ADDENDUM NO. 1

April 1, 2022

**PROJECT: Jerome Elementary School
Jerome School District
Jerome, Idaho**

A3.12
ENLARGED FLOOR PLANS

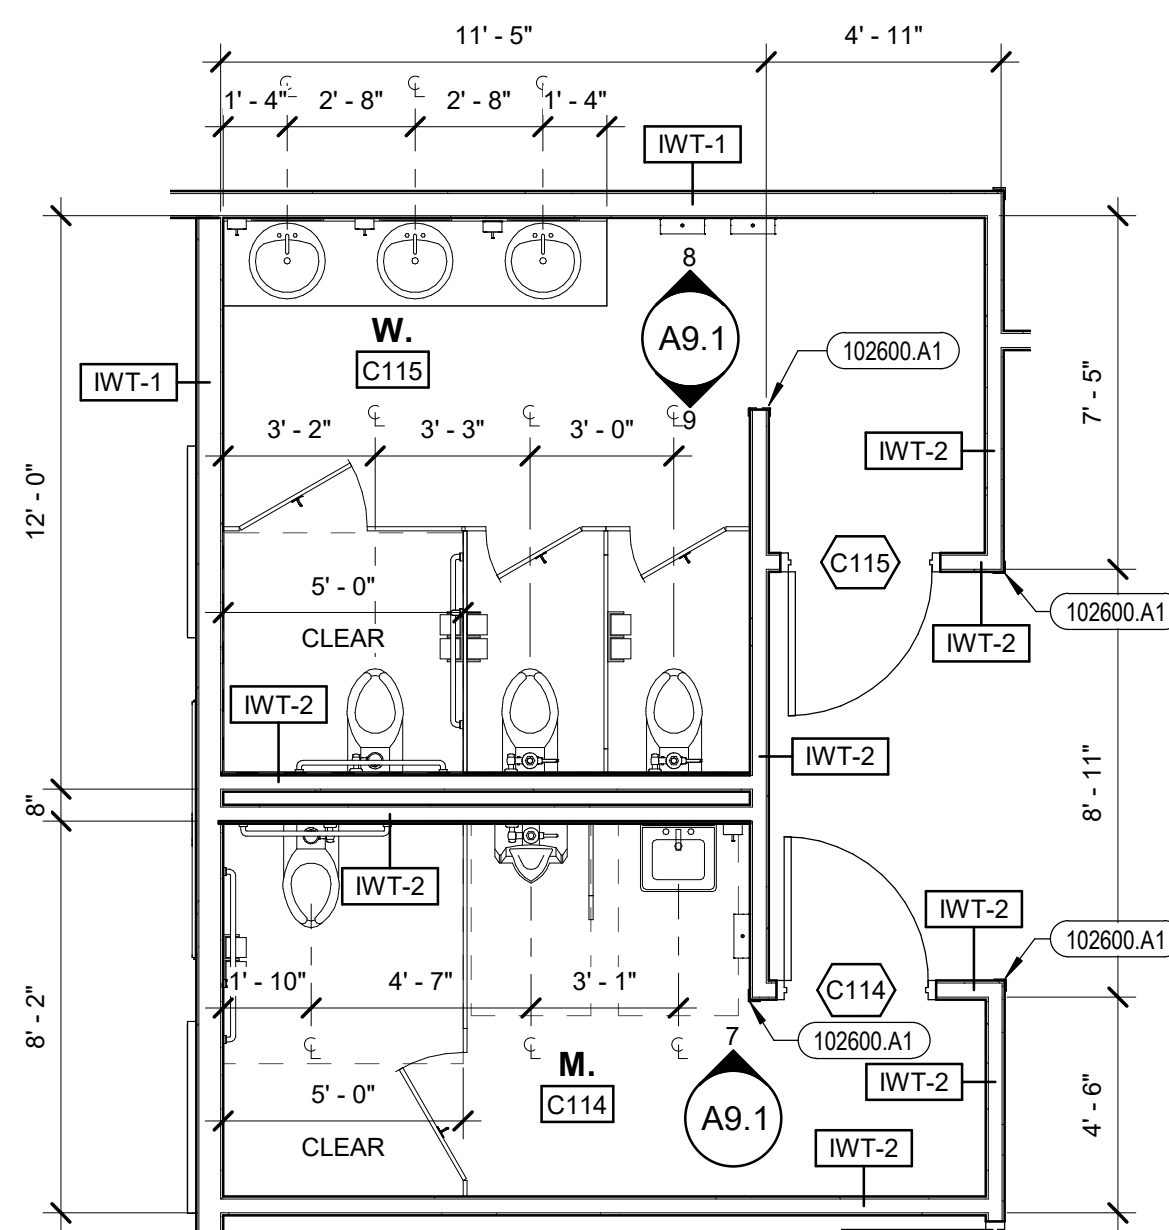
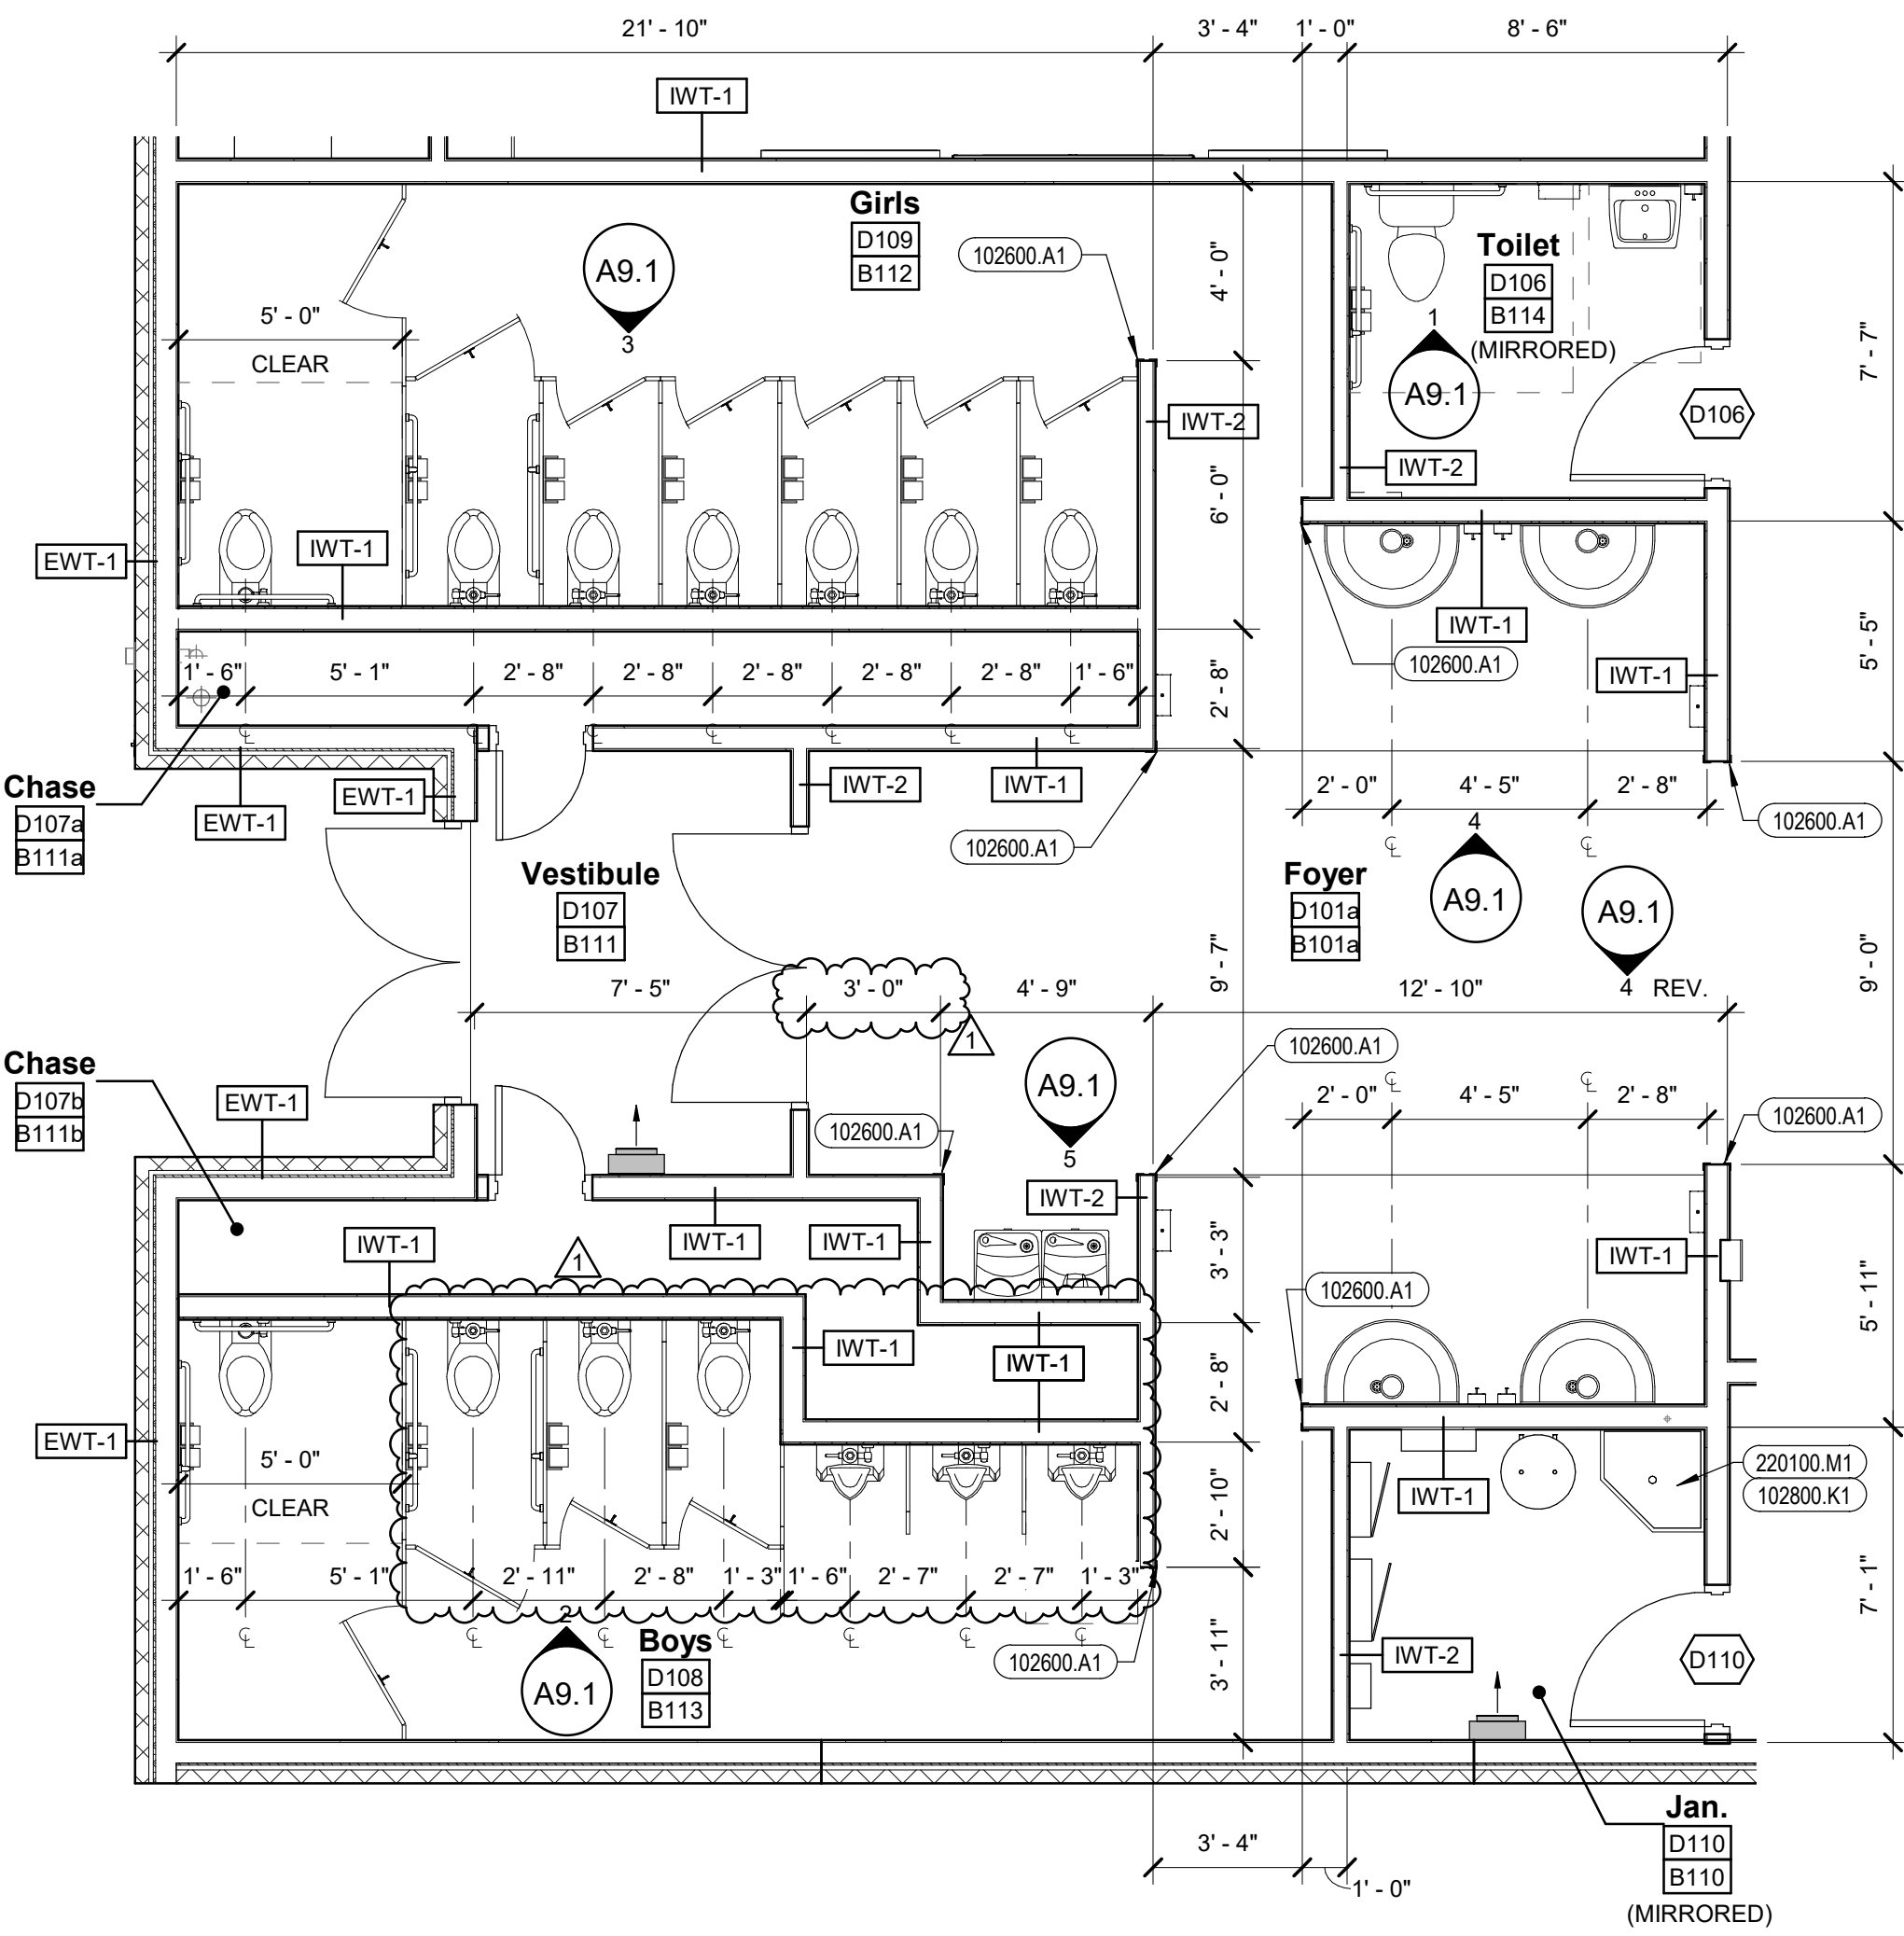
1. Revise enlarged floor plans at 1/A3.12, 4/A3.12 and 5/A3.12 as shown per revised Sheet A3.12, attached.

1. Revise elevations 2/A9.1 and 13/A9.1 to include new urinal partitions at locations indicated on A/3.12.

5 STAGE STAIR DETAIL
3/4" = 1'-0"

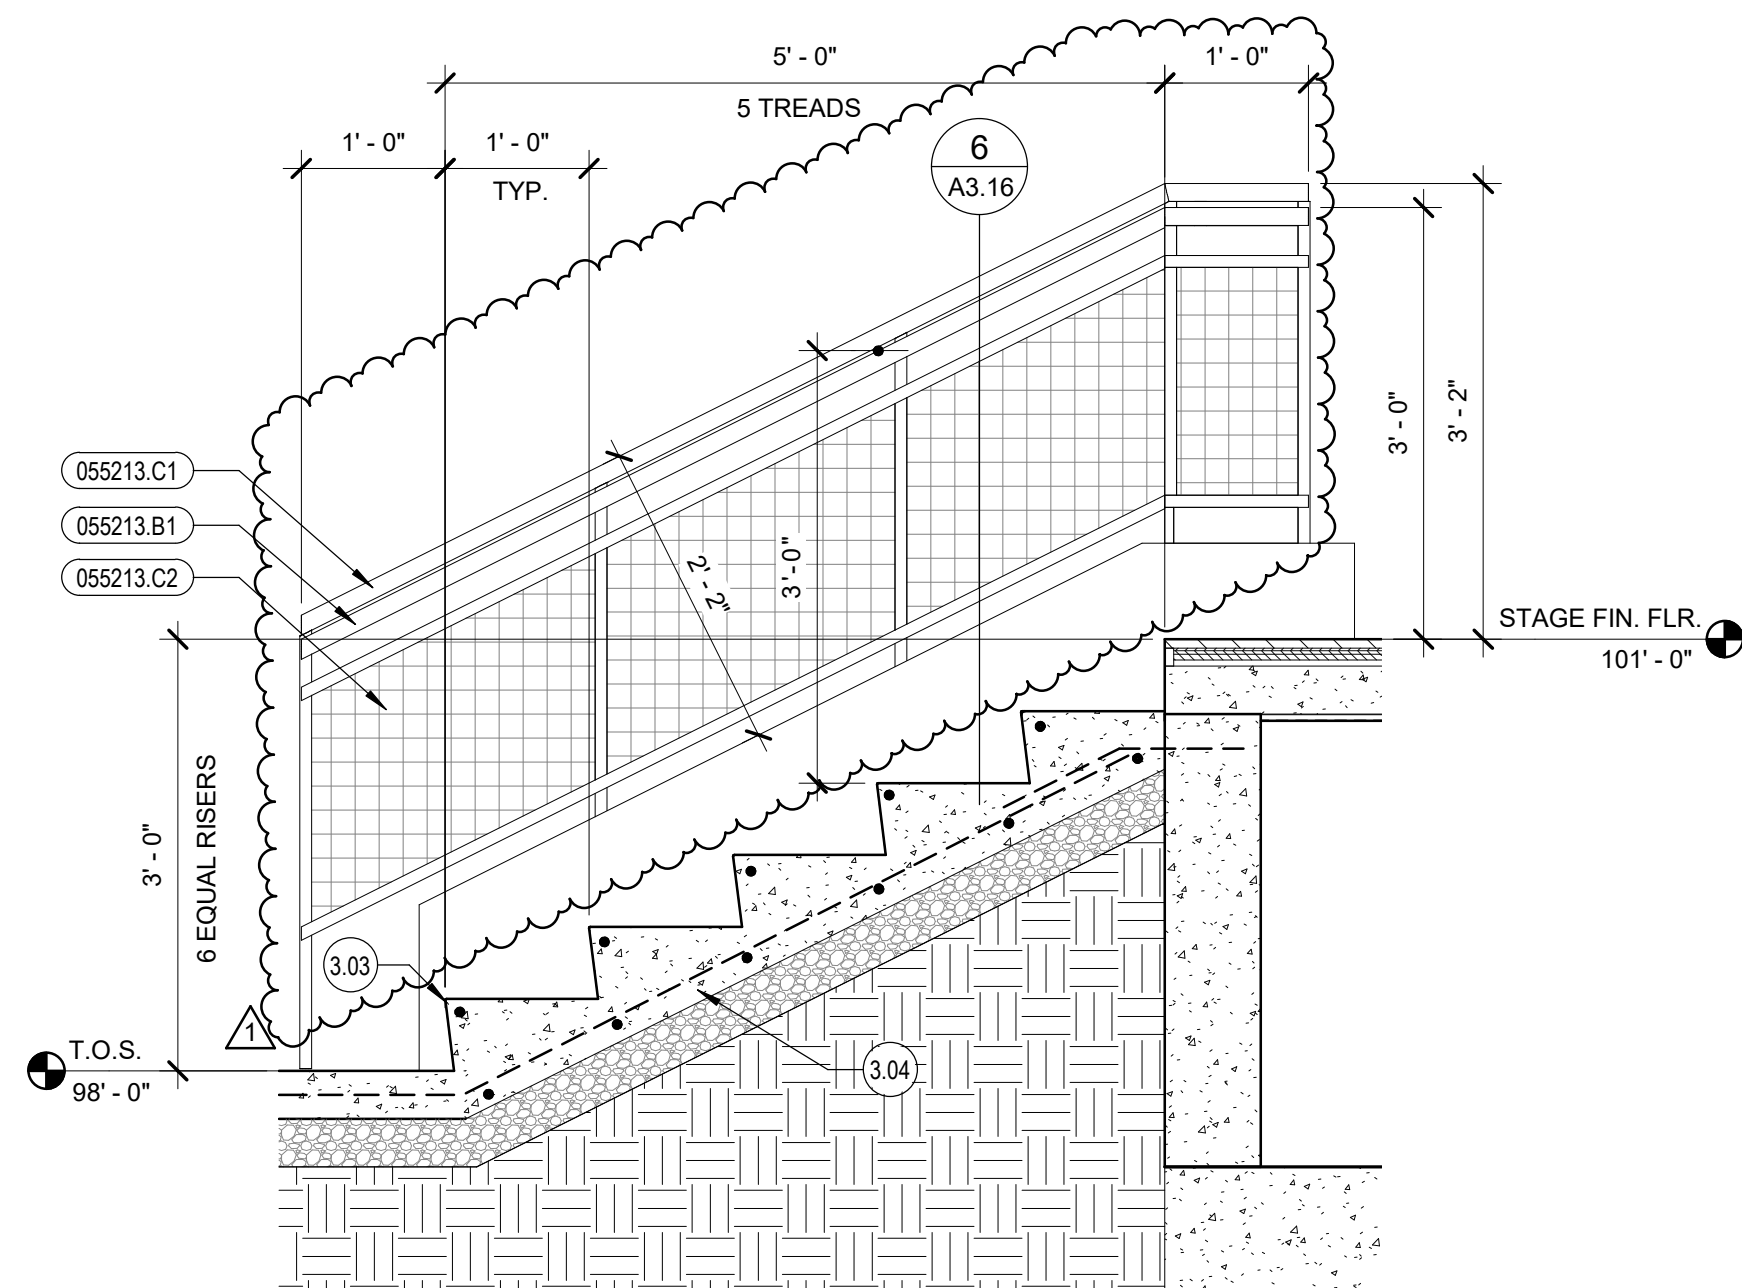
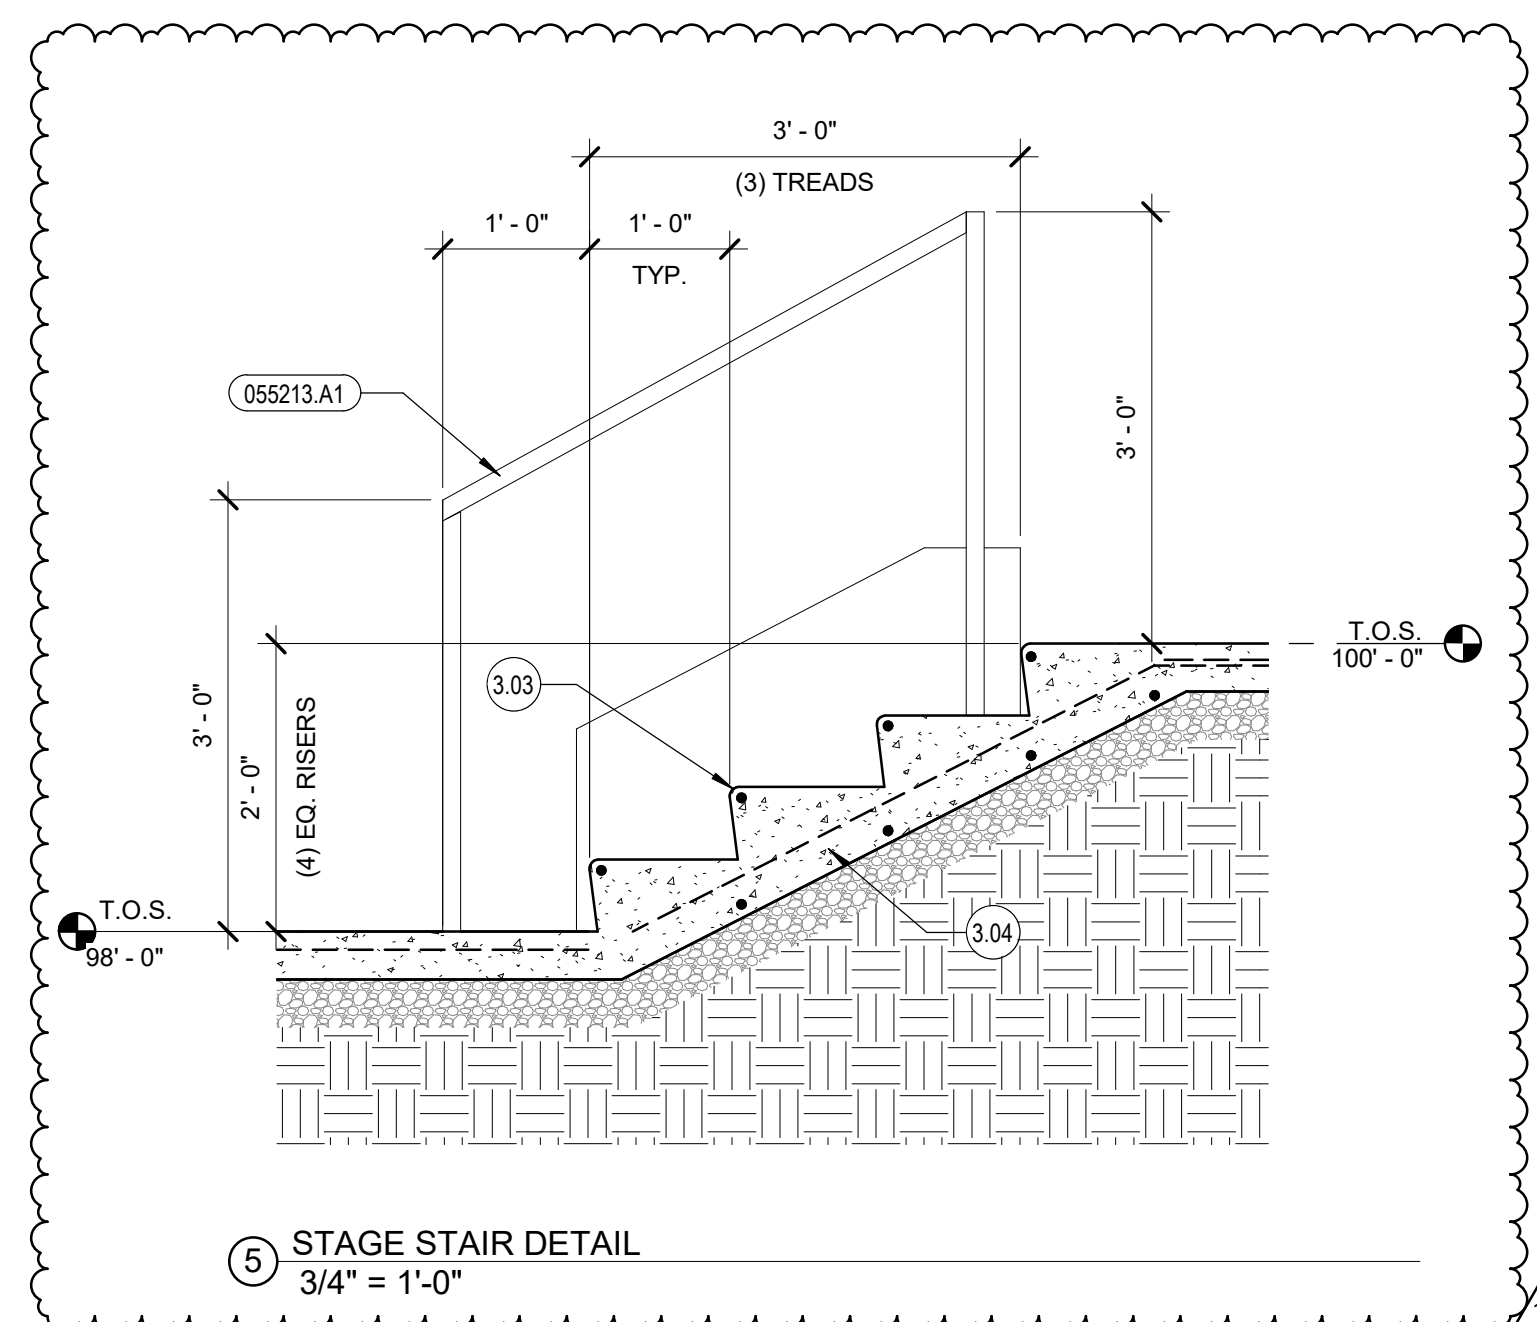
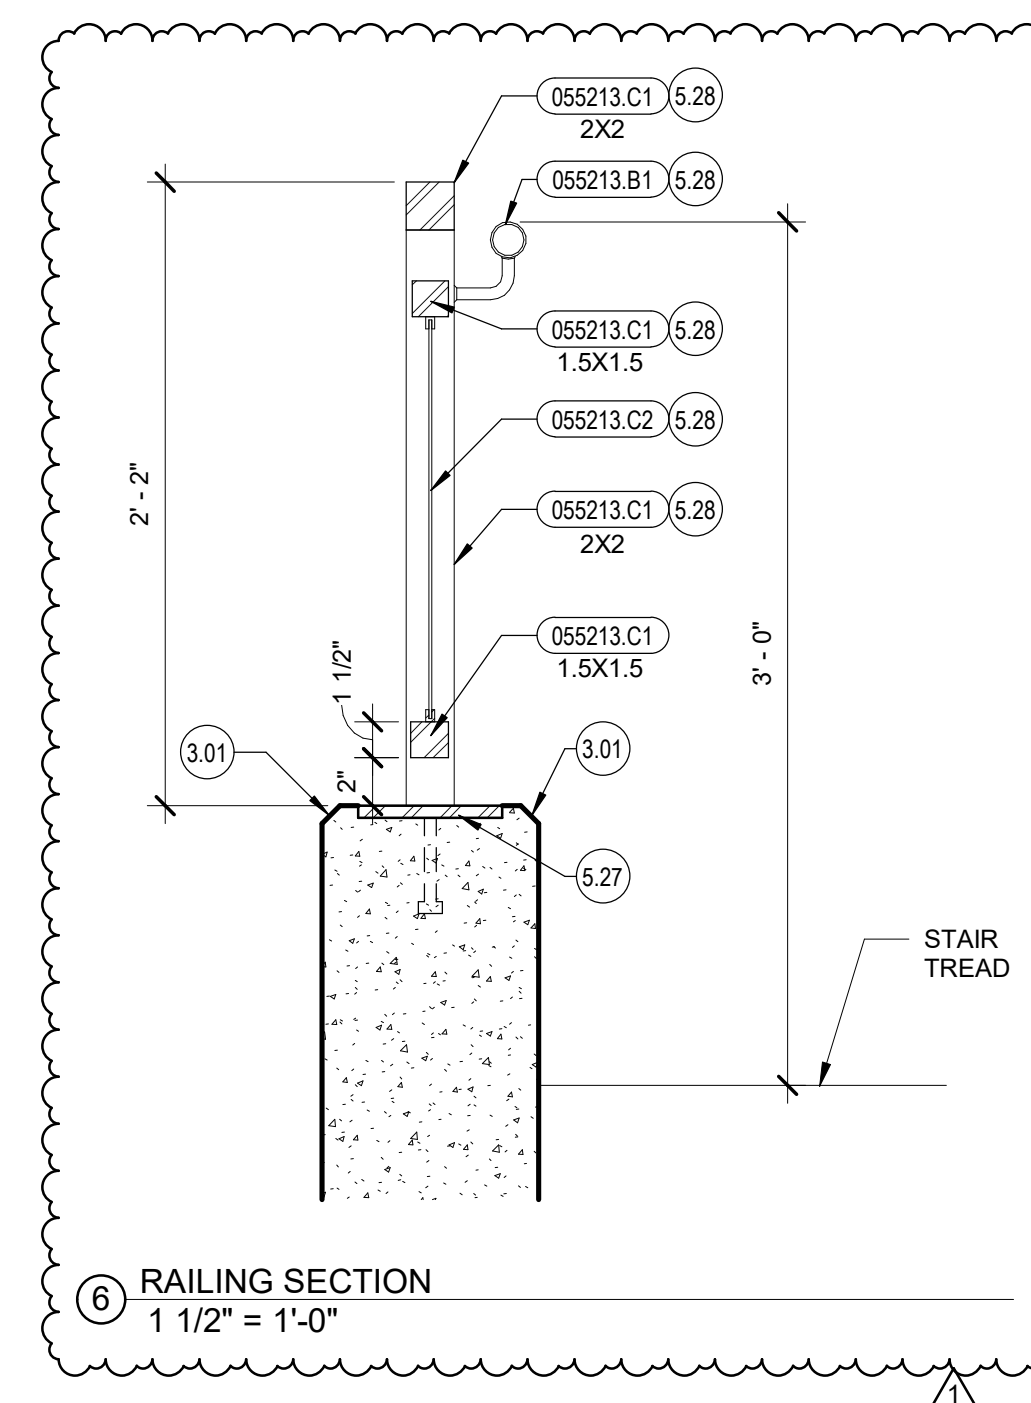
1. At detail 3/A3.15, provide new section through stair location. Section reference shall be 5/A3.16.

1. Revise detail 2/A3.16 as shown per revised Sheet A3.16, attached.
2. Provide new details 5/A3.16 and 6/3.16 as shown per revised Sheet A3.16, attached.
